TECHNICAL RESPONSE TO HCC HIGHWAYS COMMENTS

Ridge and Partners have been commissioned to respond to the Road Safety Audit undertaken by Fenley (March 2026) as part of the S278 Technical Approval Process.

Road Safety Audit Report

Proposed Continuation of Coldharbour Farm Road Emsworth

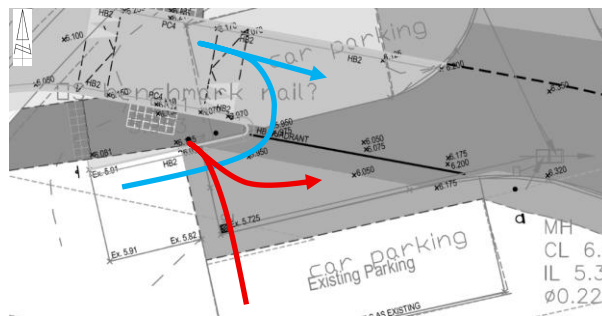
RECOMMENDATION:	
It is recommended that the carriageway is adequate for cars and LGVs to pass one another.	
Location Plan: 	
B.2	GENERAL
B.2.1	PROBLEM
Location:	Proposed continuation
Summary:	No details of the proposed raised table have been provided
Acc Type:	Vehicle to non-motorised user, sideswipe type collisions
<p>The proposals include the provision of an uncontrolled crossing over the proposed access road that is to be situated on a raised table. Whilst the provision of a raised table should ensure that motorists reduce their speed on approach, no details of the associated ramps have been provided. The Audit Team have concerns that the proposed raised table will be too shallow which will not</p>

achieve the desired speed reduction which could lead to a vehicle to non-motorised user as well as sideswipe type collisions.

It is recommended that the proposed raised table includes adequate ramps that force traffic slow.

The raised table ramp length has been designed in accordance with HCC detail HCC11/C/105 Rev B.

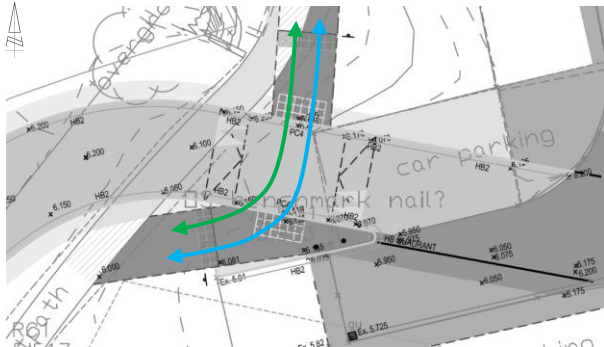
Summary: Vehicles may not be able to access the existing parking bays.

The proposals include the continuation of Coldharbour Farm Road where a number of parking bays are provided both sides of the carriageway. The existing parking cul-de-sac off the northern side is to remain largely unchanged with a 6.0 metre aisle that allows for easy access to each bay and an edge of carriageway marking provided which will highlight priorities. It is noted, however, that the parking bays to the south of Coldharbour Farm Road do not benefit from an aisle that is of adequate width to allow a car to turn (6 metres). Motorists wishing to access the existing bays, will therefore be required to reverse off or onto the Coldharbour Farm Road carriageway. Speeds will be low and therefore motorists should become aware of one another and proceed accordingly. The Audit Team have concerns, however, that a vehicle will be required to encroach the proposed uncontrolled crossing or shared footway cycleway when manoeuvring into / out of the existing spaces which could lead to vehicle to non-motorised user type collisions.

It is recommended that the bays are accessible.

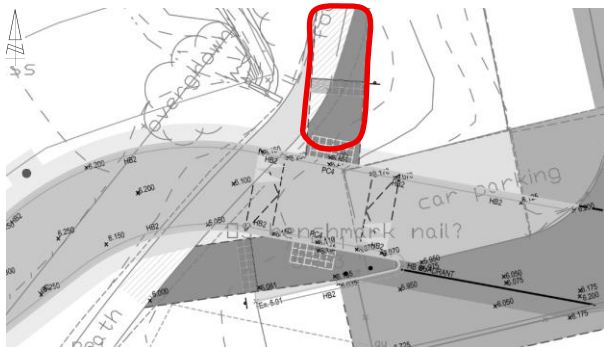
RECOMMENDATION:	
It is recommended that an appropriate level of visibility is achievable.	
<p>Location Plan:</p>  	
B.4.2	PROBLEM
Location:	Coldharbour Farm Road
Summary:	Non-motorised users at and on approach to the uncontrolled crossing may not be clearly visible during the hours of darkness
Acc Type:	Vehicle to pedestrian type collisions
<p>The public footpath 108/71/1 that is present to the west of the Coldharbour Farm Road cul-de-sac provides a link between the facilities available at Emsworth Park and the residential areas to the south. During the site visits associated with this scheme, numerous pedestrians to include joggers and cyclists have been observed. The proposals include the continuation of Coldharbour Farm</p>

<p>Road to the west severing the existing footpath. As part of the proposals, an uncontrolled crossing is to be provided on a raised table. This crossing is to benefit from tactile paving to a depth of 1200mm which should be sufficient to warn all pedestrians of the live carriageway. The scheme drawing illustrates that visibility splays of 2.4x43 metres are achievable from the uncontrolled crossing, however, they do not extend to the tangent and it is noted that the footpath is not illuminated. The Audit Team have concerns that visibility of a non-motorised users immediately approaching the proposed uncontrolled crossing is limited, particularly during the hours of darkness which could lead to a vehicle to pedestrian type collision.</p>

<p>RECOMMENDATION:</p>	
<p>It is recommended that visibility is achievable to the tangent and that the proposed crossing point is illuminated adequately with a column provided immediately to the west of the crossing point as previously proposed.</p>	
<p>Location Plan:</p> <div></div>	
<p>B.5</p>	<p>TRAFFIC SIGNS, CARRIAGEWAY MARKINGS AND LIGHTING</p>
	<p><i>No Road Safety Concerns regarding TRAFFIC SIGNS, CARRIAGEWAY MARKINGS AND LIGHTING have been raised at this stage</i></p>

TITLE: S278 COMBINED

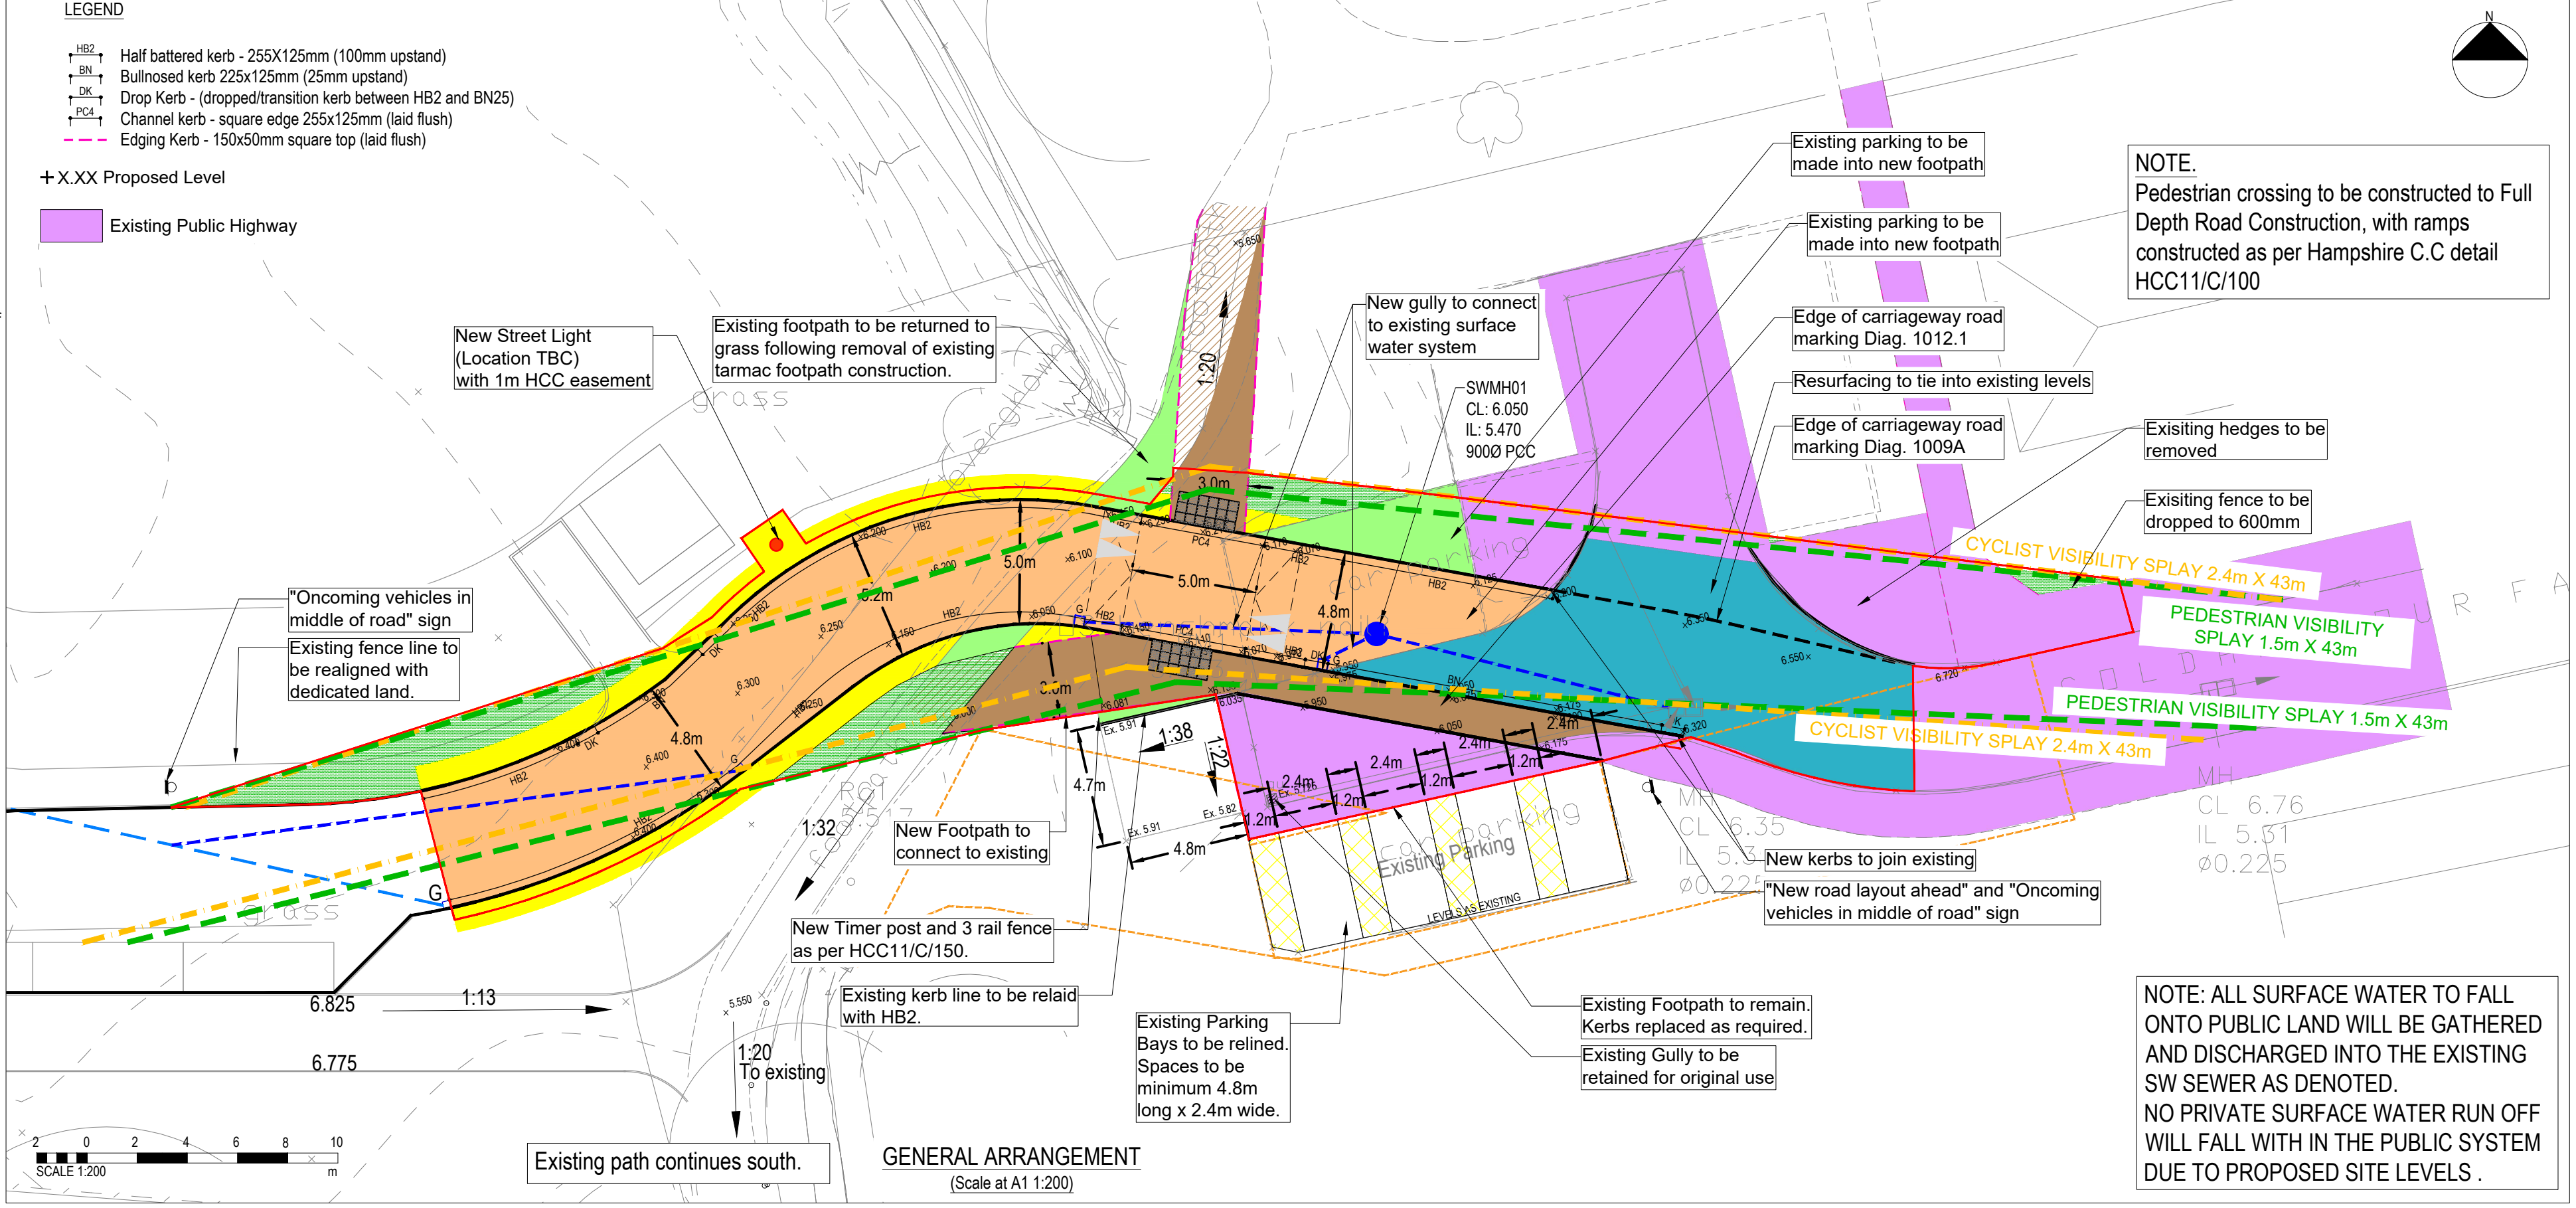
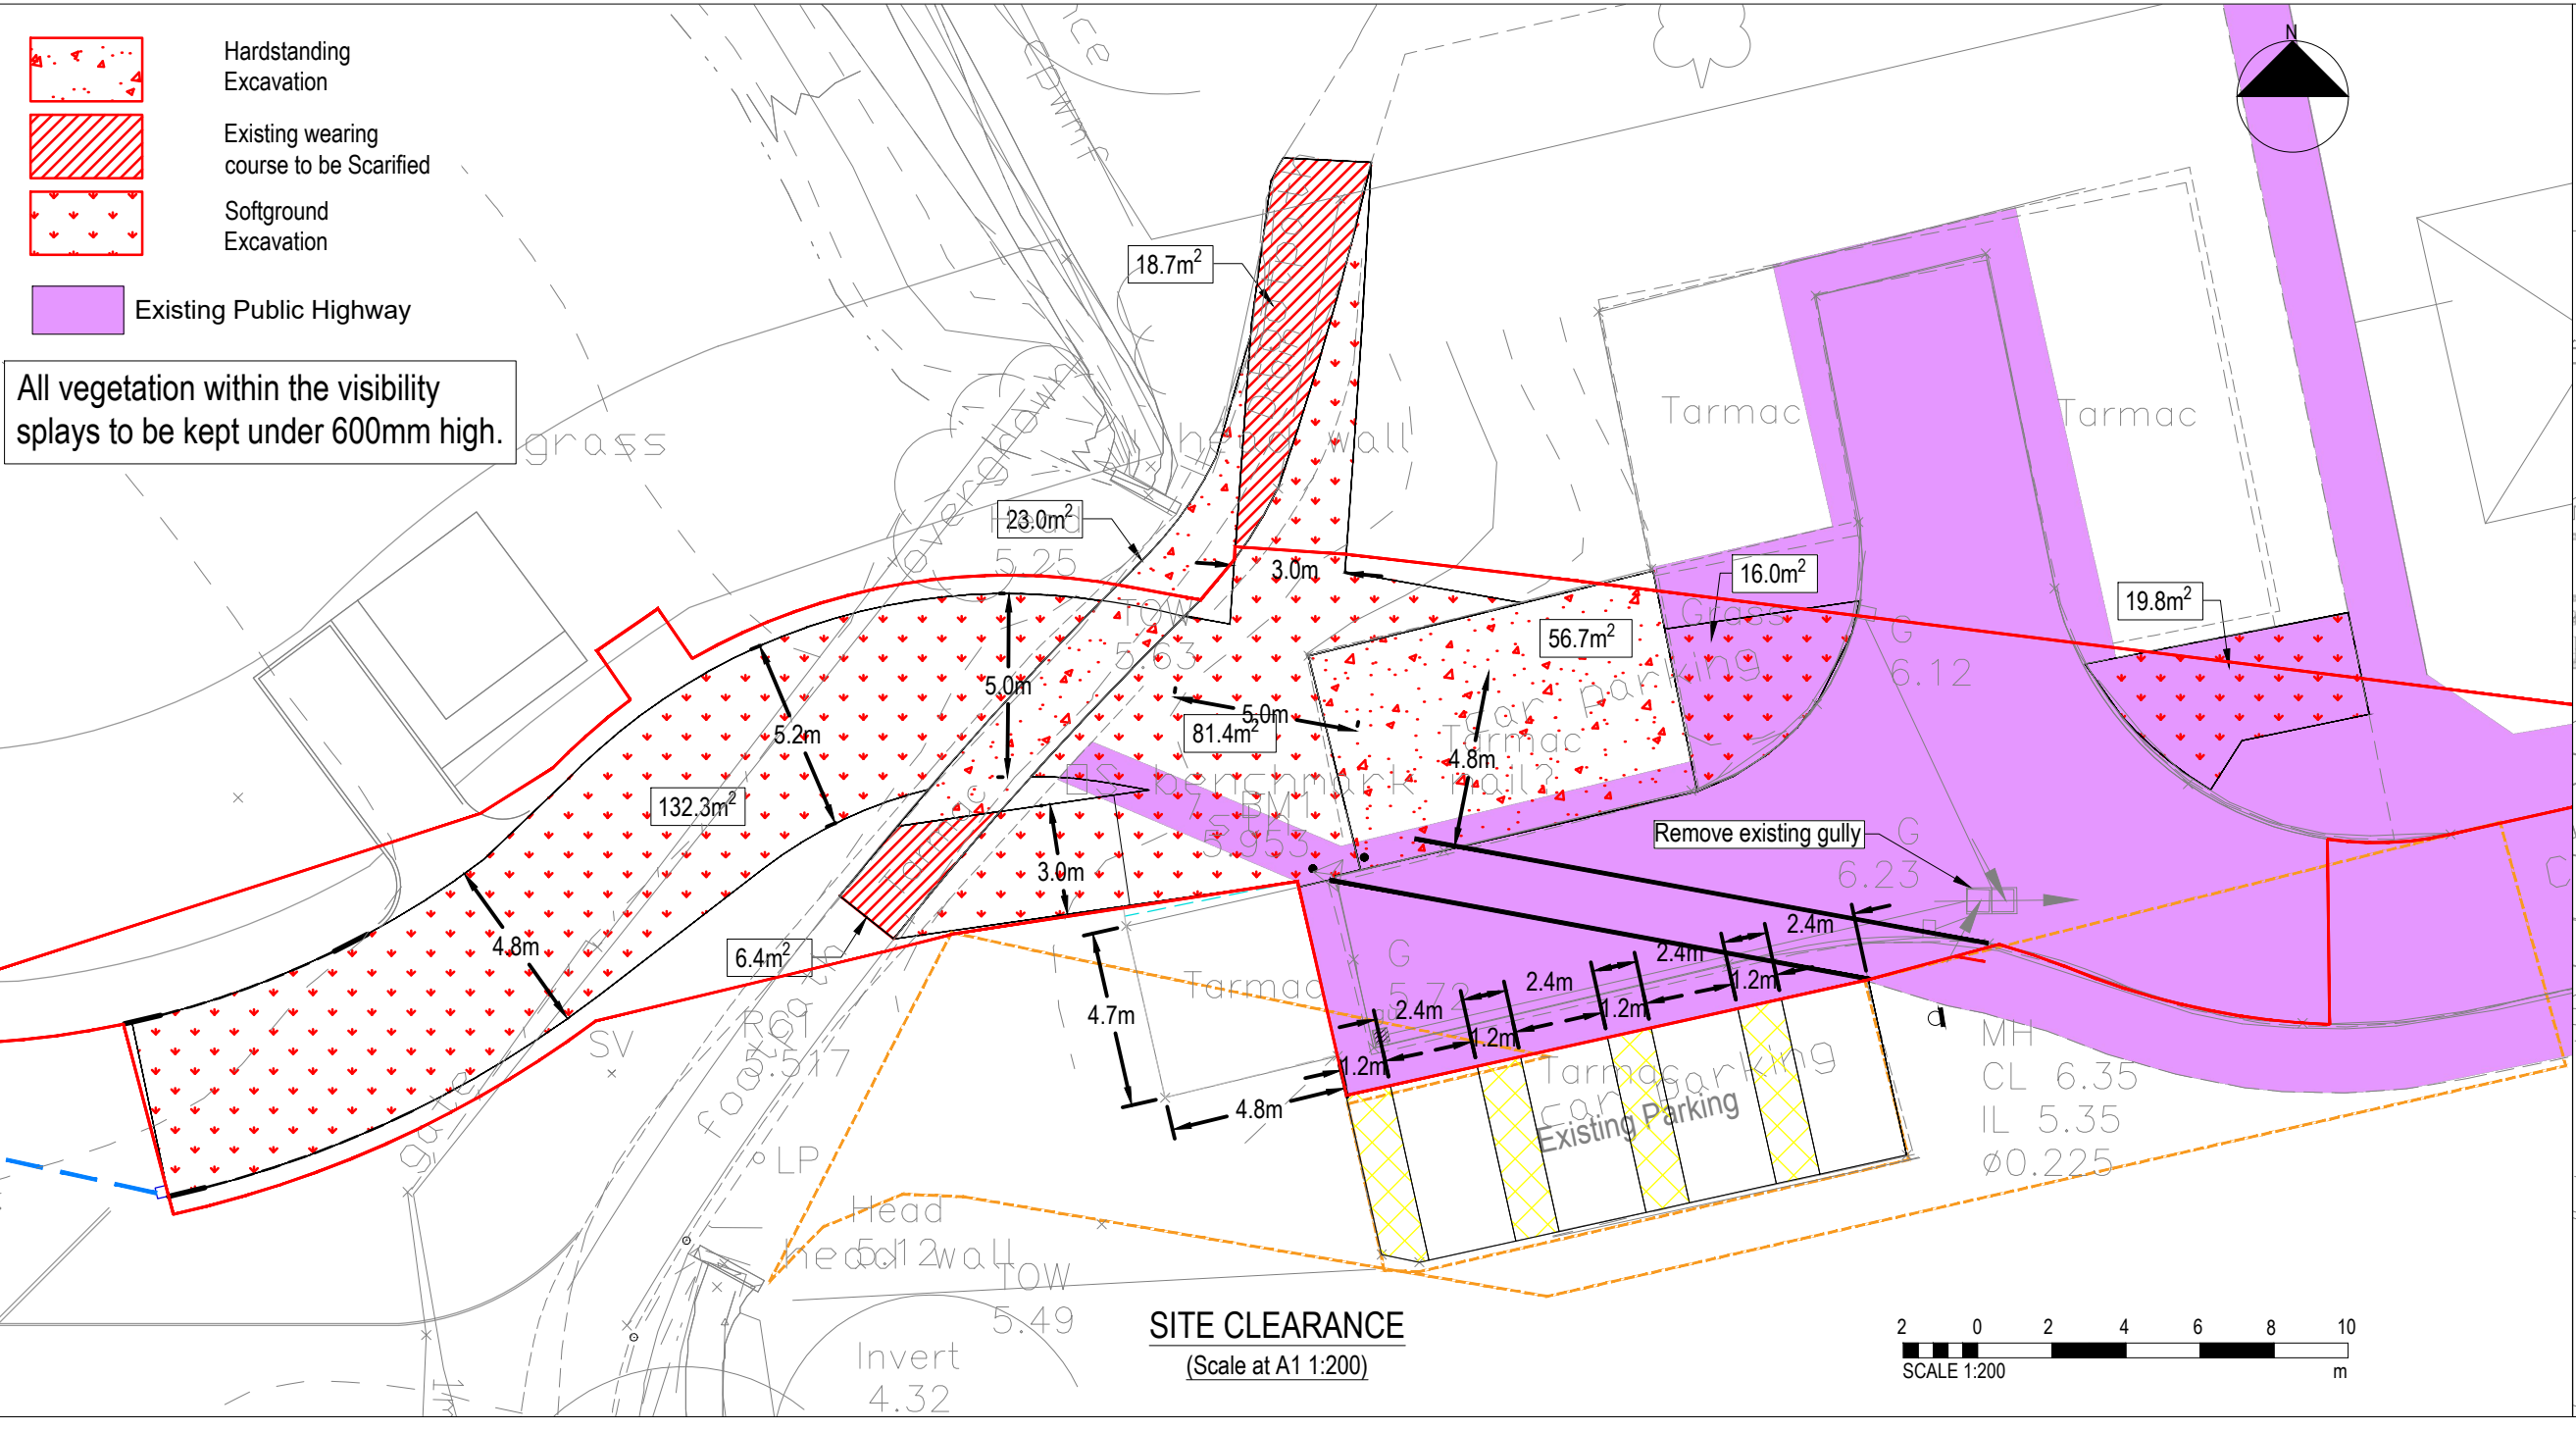
B.4.1 - Cyclists are likely to continue without giving way to traffic. It is recommended that an appropriate level of visibility is achievable.

B.4.2 - Non-motorised users at and on approach to the uncontrolled crossing may not be clearly visible during the hours of darkness. It is recommended that visibility is achievable to the tangent and that the proposed crossing point is illuminated adequately with a column provided immediately to the west of the crossing point as previously proposed.

Suitable visibility splays for cyclists are as shown on Drawing 23339-JUBB-XX-XX-DR-X-000100 REV C13. In dashed orange. With regards to lighting, this has been confirmed as suitable by the lighting designer.

Suitable visibility splays for pedestrians are as shown on Drawing 23339-JUBB-XX-XX-DR-X-000100 REV C13. In dashed yellow. With regards to lighting, this has been confirmed as suitable by the lighting designer.
